Petition Number: #2022-123

General Review Information

Transportation Summary

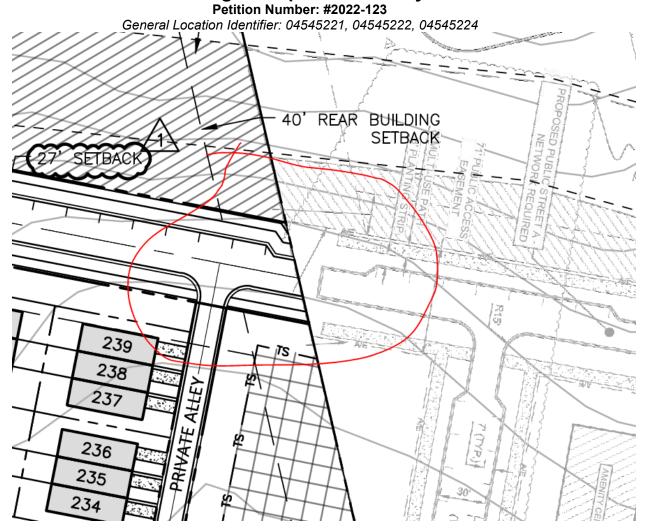
4. New comment from 03-30-2023: Revise site plan and conditional note(s) by removing callout from site plan and conditional note 3.k.

Remove

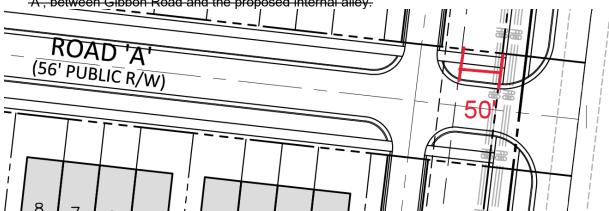
11. Revise site plan to provide a minimum internal stem length of 50' between radius returns along Road 'A', between Gibbon Road and the proposed internal alley.
